**Subject:** FW: Stakers Farm

**PROJECT**  
BARNs AT STAKERS FARM  
NORTH END ROAD  
YAPTON BN18 0DU

DRAWING TITLE  
PROPOSED SITE LAYOUT

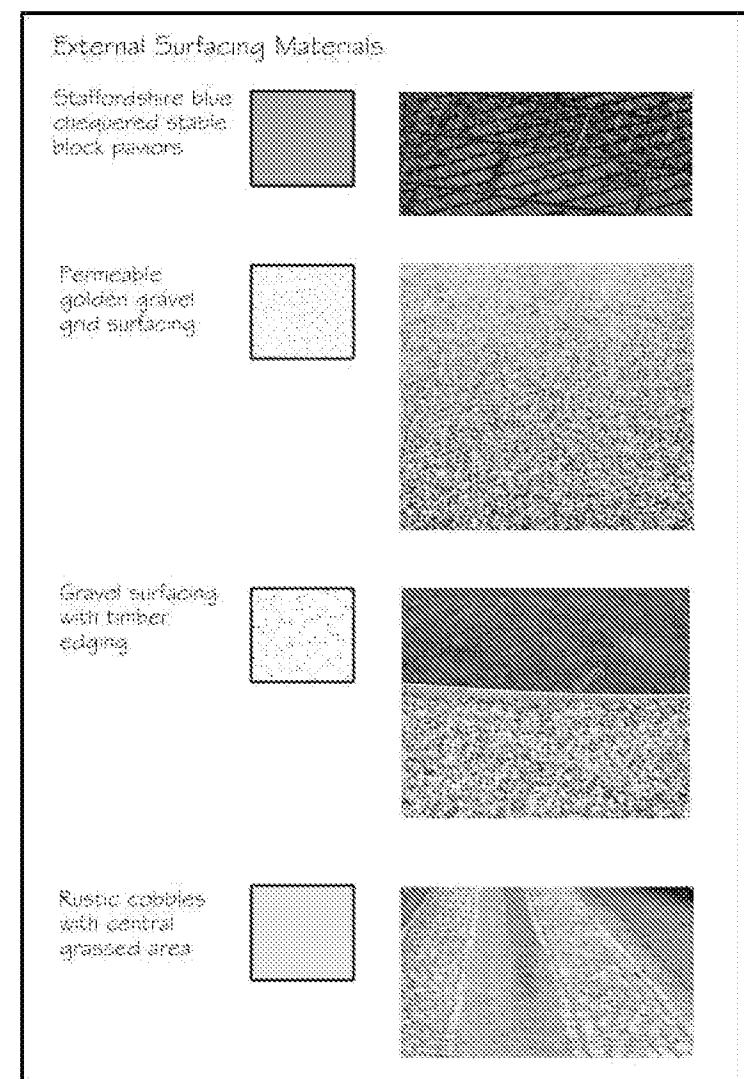
Apologies for the delay in sending this further information over and thank you for your time on the phone last month. Please find attached an updated site plan which includes changes to materials, amended elevation, and a picture of the existing barn 2 elevation that I believe you were concerned about.

- Surfacing materials for the access and parking areas – we have changed the previously proposed brick paviors within the parking areas to permeable gravel laid within a grid system with blue stable bricks for the pedestrian areas.

- Barn 2 potential for window to dominate the elevation - As shown on the attached photo, this is an original cart shed opening which has previously been crudely infilled with brickwork and a door. The original timber beam above the opening is still in position, and this will be retained and used as the top of the reinstated opening. The removal of the door and infilled brickwork will reinstate the original opening, and this will be clearly expressed with a simple, full height glazed screen.

- Barn 1 south east elevation - The proposed windows to the south east elevation of Barn One are all within existing openings and would all serve bedrooms. We have now omitted the horizontal boarding to the window serving bedroom 3 and shown this as full height glazing to match the other proposed windows. Can window details be dealt with via condition if needed?
